Subject: Class 3 Permit Modification Request, Construction and Use of Hazardous Waste Disposal Units 11 and 12 for the Waste Isolation Pilot Plant Hazardous Waste Facility Permit Number: NM4890139088-TSDF

**Class 3 Permit Modification Request**

**Construction and Use of Hazardous Waste Disposal Units 11 and 12**

**Waste Isolation Pilot Plant  
Carlsbad, New Mexico**

**Figure A2-1**  
**Repository Horizon**

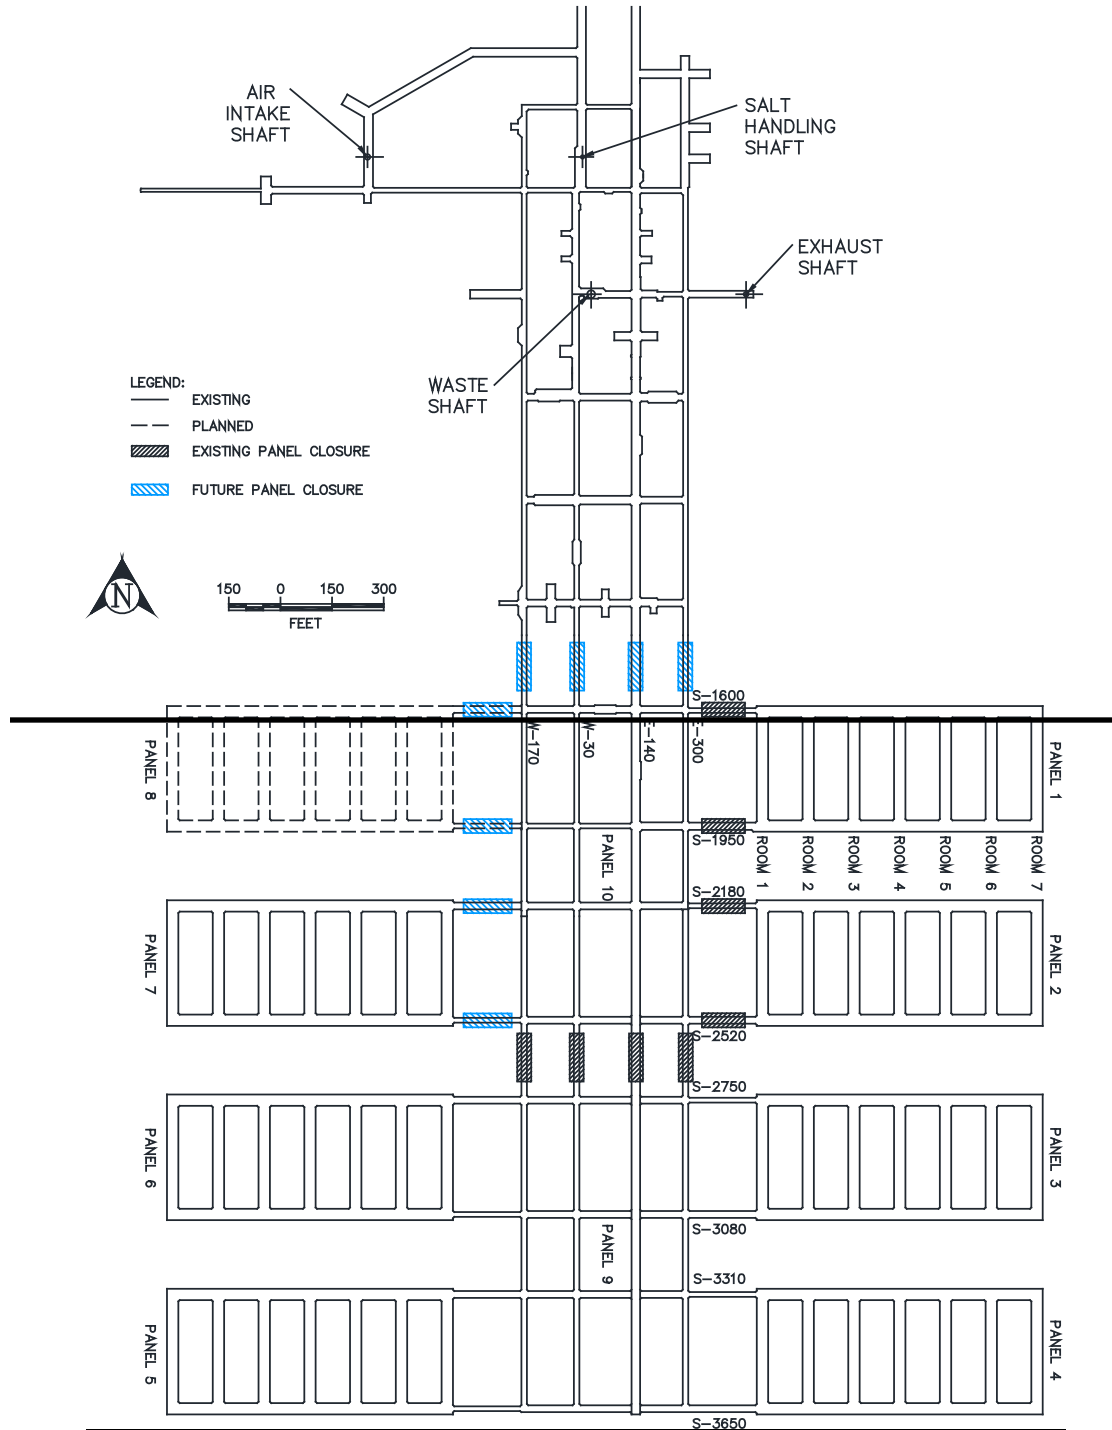
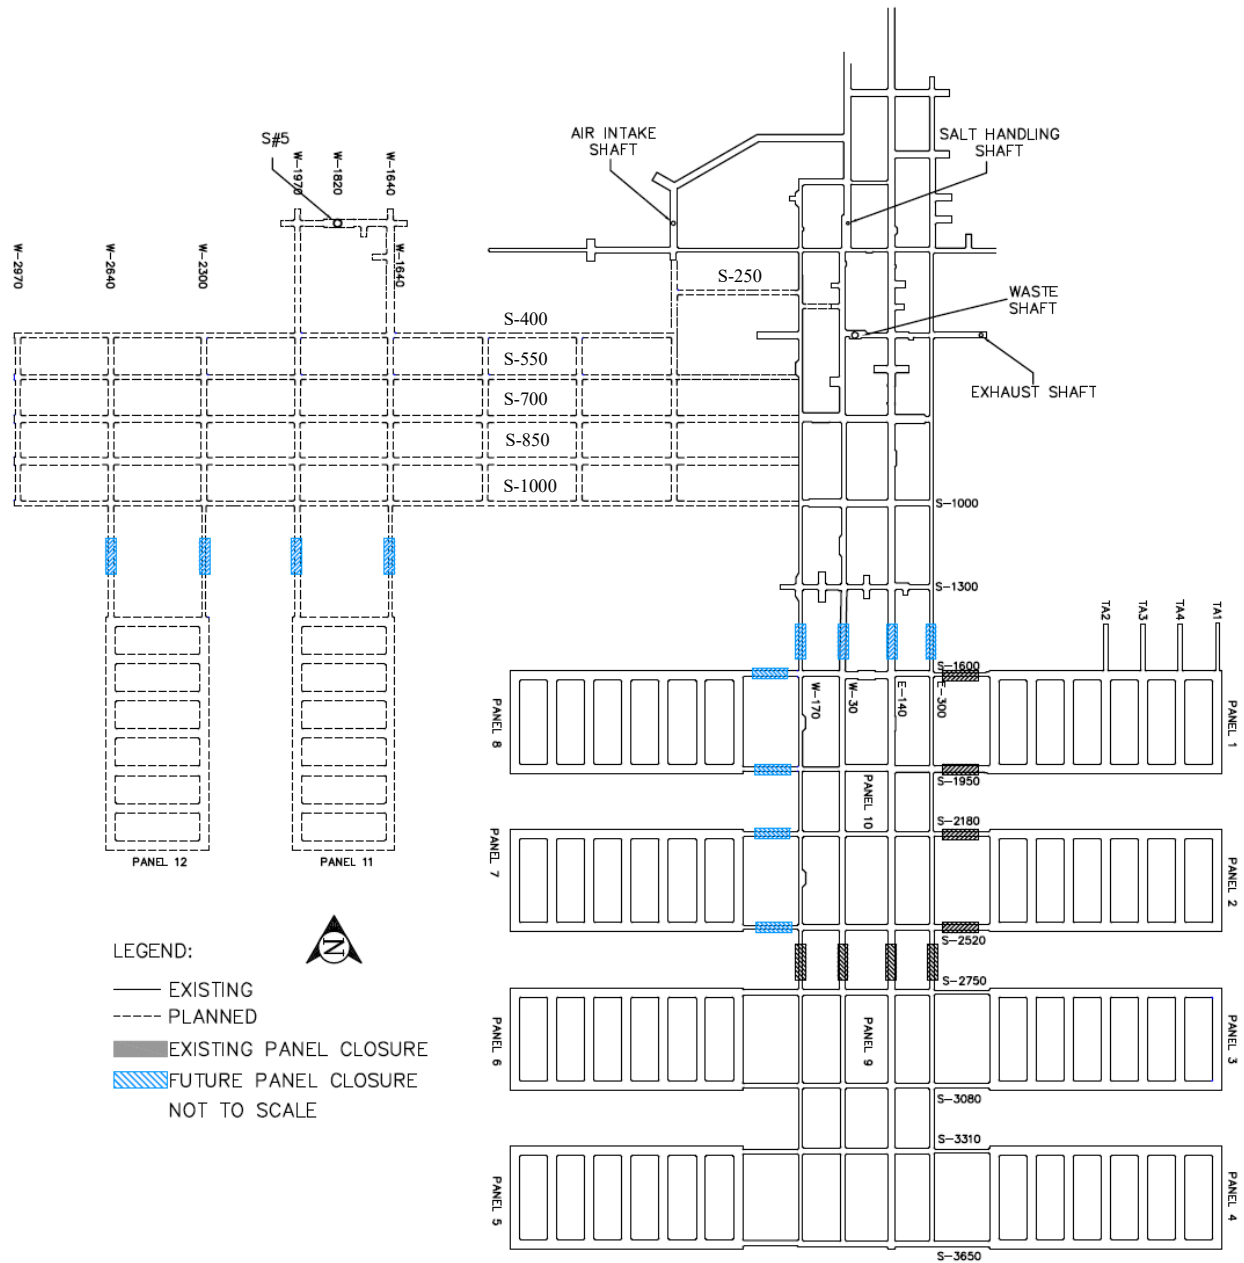
| Permit Part/Section                              | Impact  |
|--|---|
| Attachment A2, Figures                           | Modified Figures A2-1, <i>Repository Horizon</i> , and A2-2, <i>Spatial View of the Miscellaneous Unit and waste Handling Facility</i> , to show the West Mains and proposed Panels 11 and 12 as planned excavations in the underground repository. This change is needed for accurate depiction of the layout of the underground repository.   |

| Affected Permit Section                                 | Explanation of Change   |
|---|---|
| Attachment A2, Figures                                  | Replaced Figure A2-1, <i>Repository Horizon</i> , by adding the West Mains and Panels 11 and 12 to the repository layout.   |

**Figure A2-2**  
**Spatial View of the Miscellaneous Unit and Waste Handling Facility**

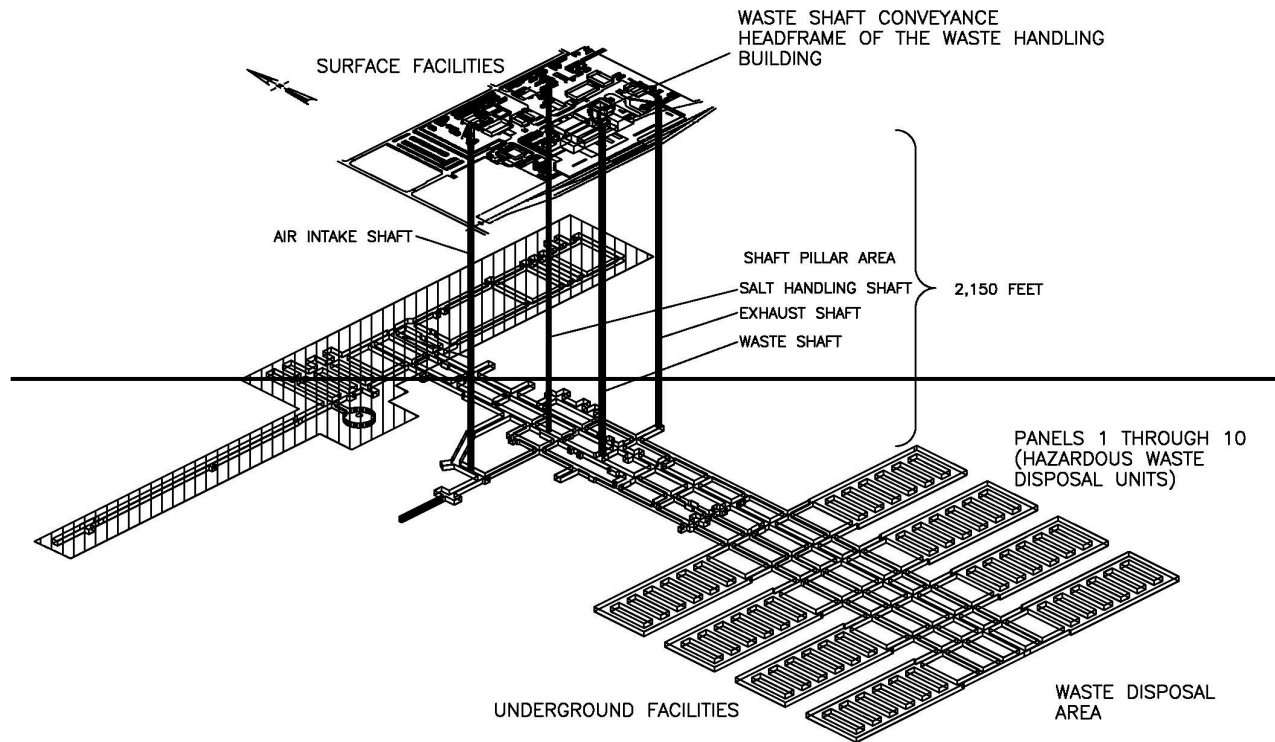
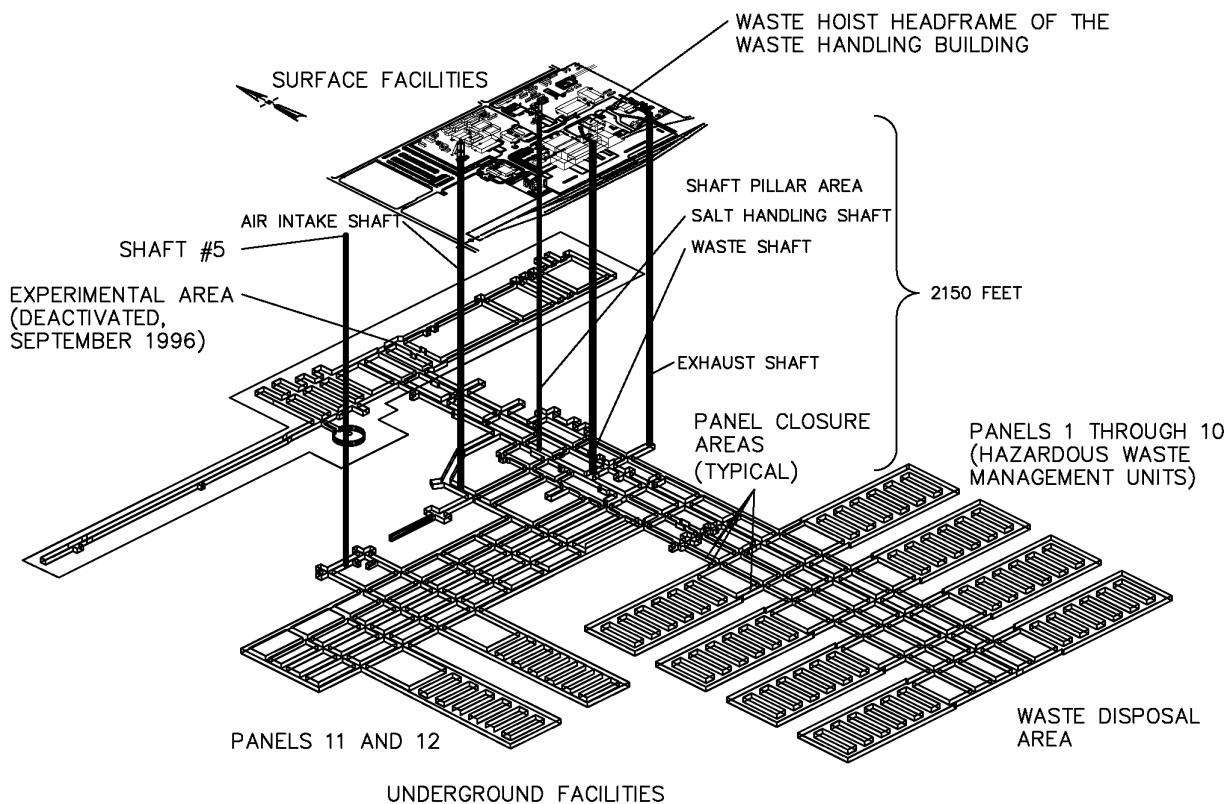
| Affected Permit Section                                 | Explanation of Change   |
|---|---|
| Attachment A2, Figures                                  | Replaced Figure A2-2, <i>Spatial View of the Miscellaneous Unit and Waste Handling Facility</i> , to include the West Mains and Panels 11 and 12.   |

**Figure A4-4**  
**Typical Underground Transport Route Using E-140**

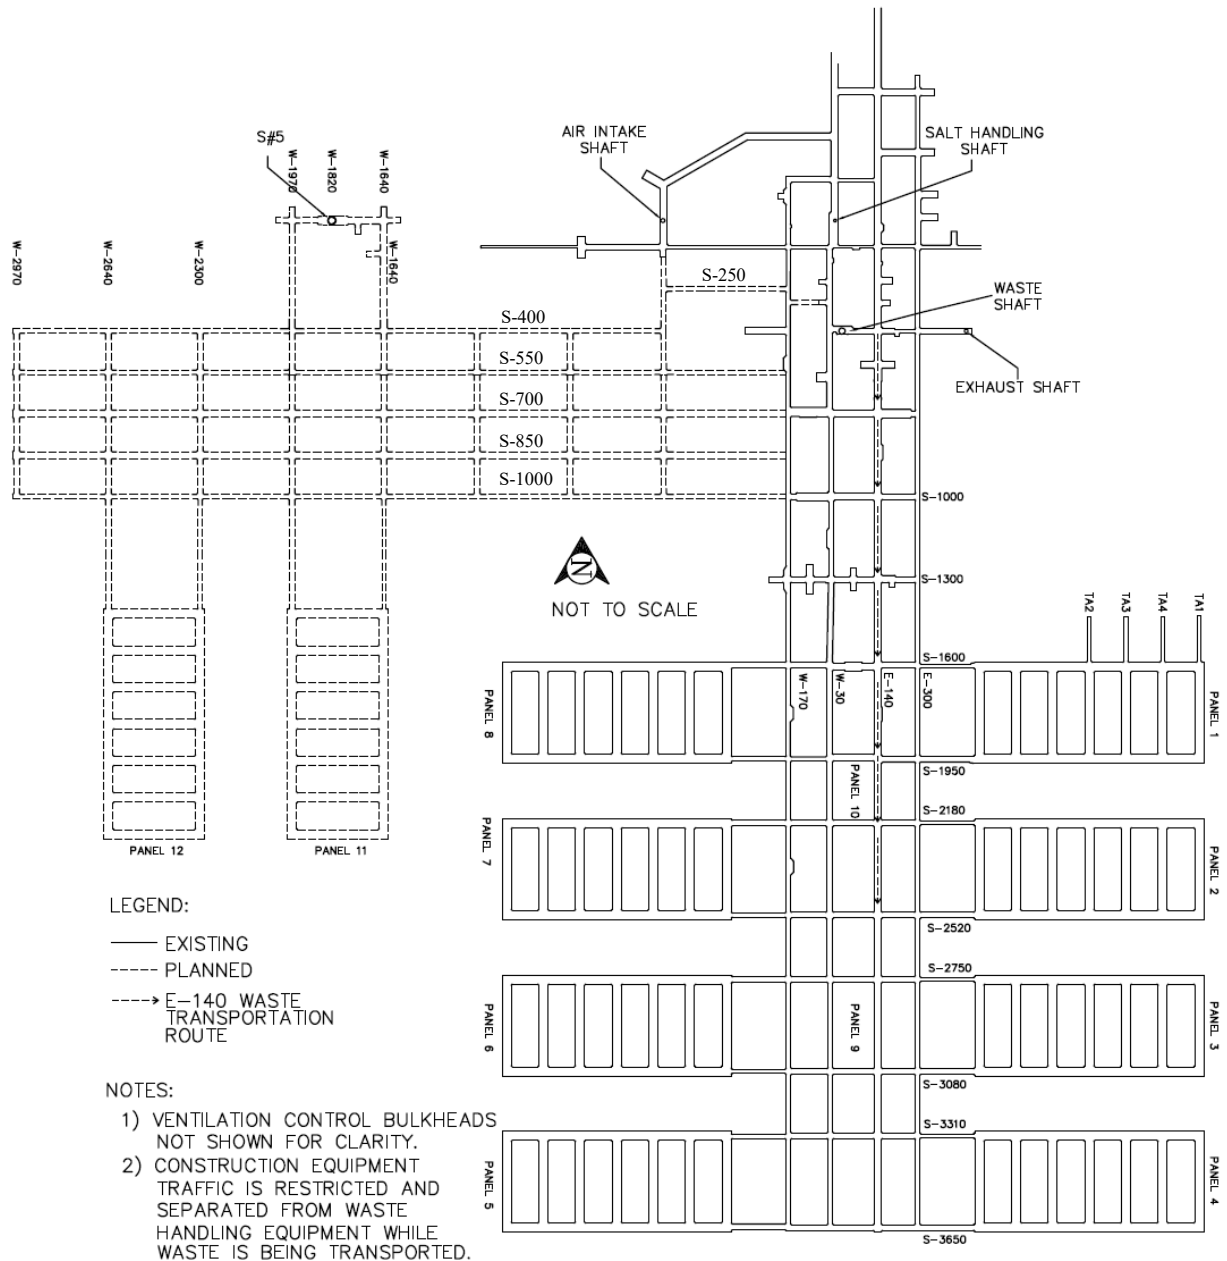
| Permit Part/Section                              | Impact  |
|--|---|
| Attachment A4, Figures                           | Modified Figure A4-4, <i>Typical Underground Transport Route Using E-140</i> , to show the West Mains and Panels 11 and 12. This change is needed to accurately reflect the underground layout.   |

| Affected Permit Section                                 | Explanation of Change   |
|---|---|
| Attachment A4, Figure A4-4                              | Replaced figure to show the West Mains and Panels 11 and 12.  |

**Figure A4-4a**  
**Typical Underground Transport Route Using W-30**

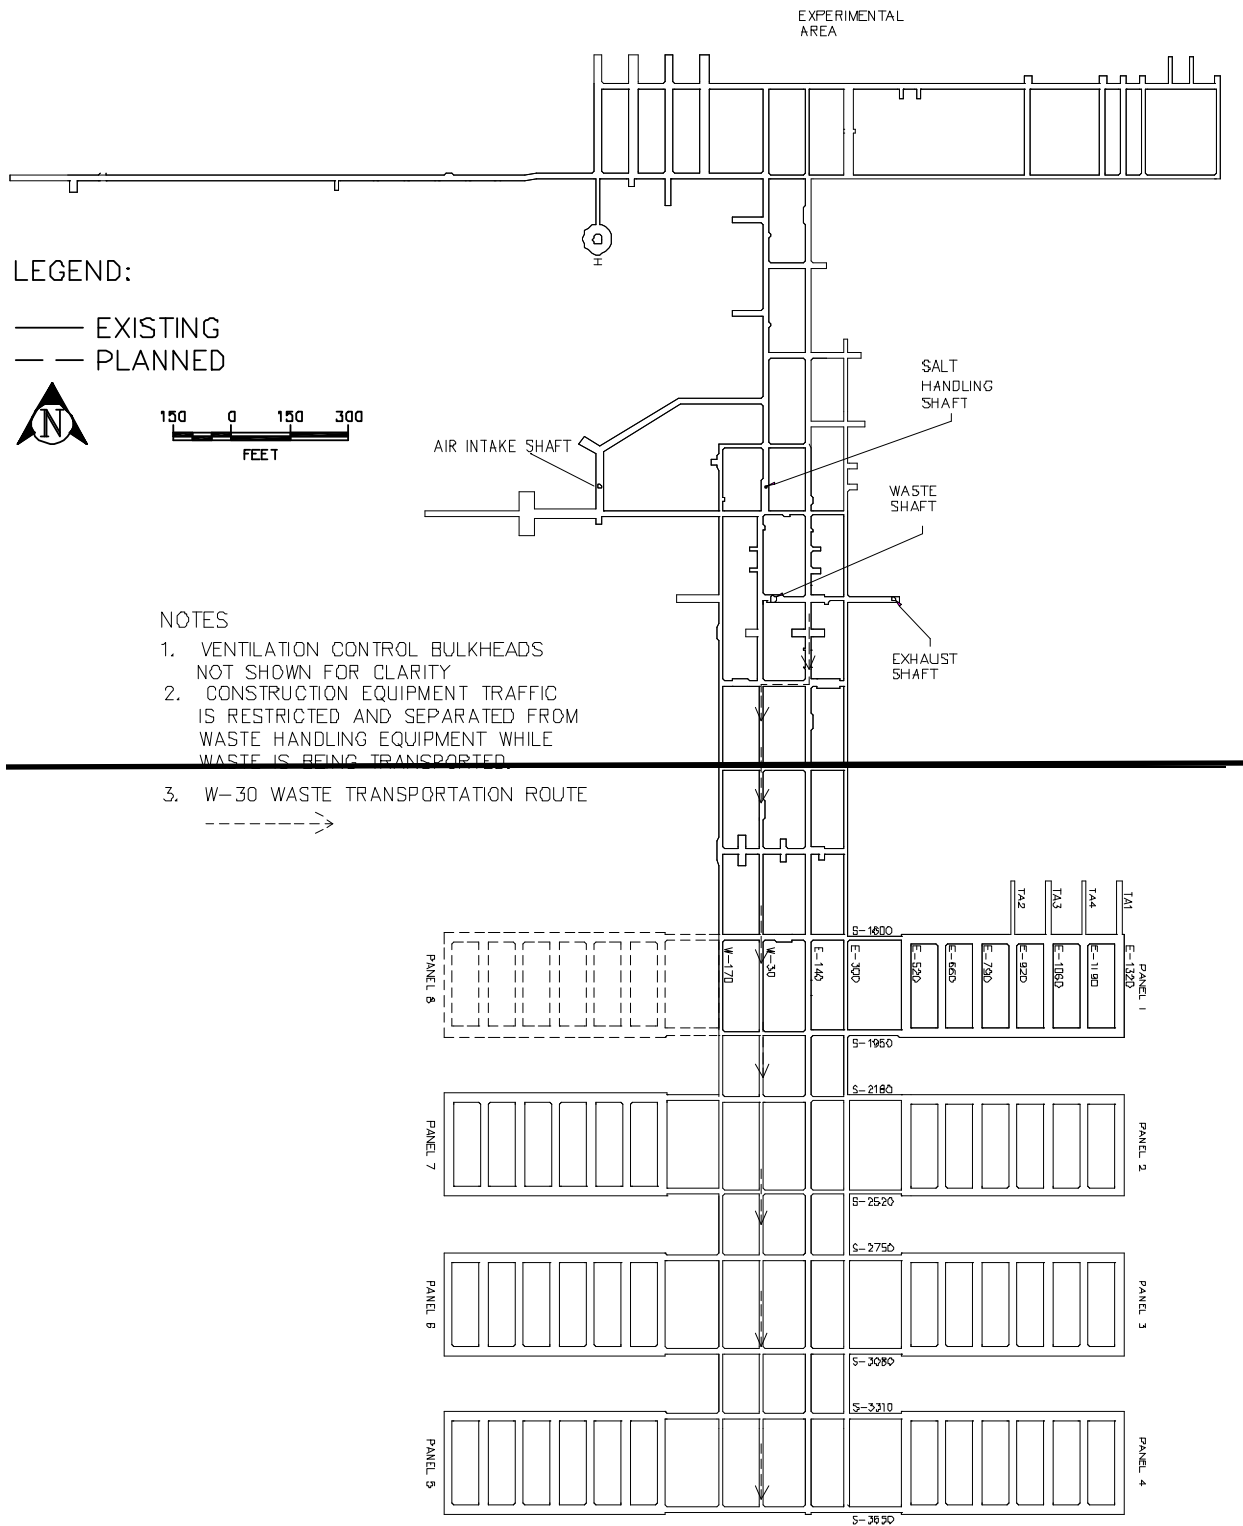
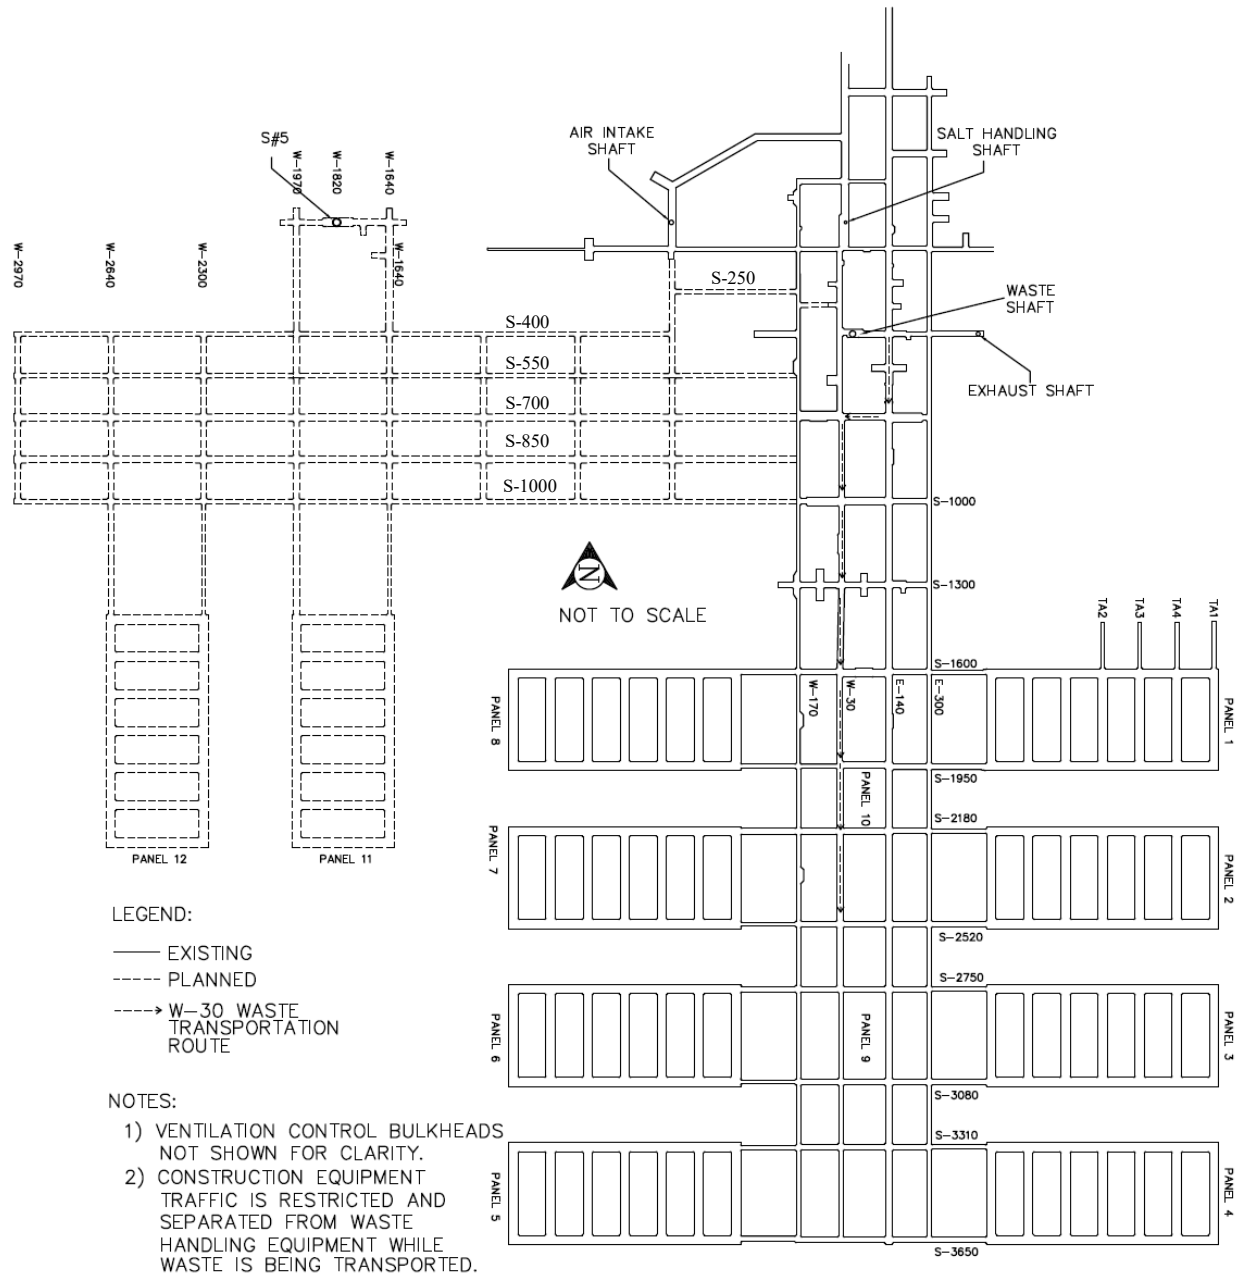
| Permit Part/Section                              | Impact  |
|--|---|
| Attachment A4, Figures                           | Modified Figure A4-4a, <i>Typical Underground Transport Route Using W-30</i> , to show the West Mains and Panels 11 and 12. This change is needed to accurately reflect the underground layout.   |

| Affected Permit Section                                 | Explanation of Change   |
|---|---|
| Attachment A4, Figure A4-4a                             | Replaced figure to show the West Mains and Panels 11 and 12.  |
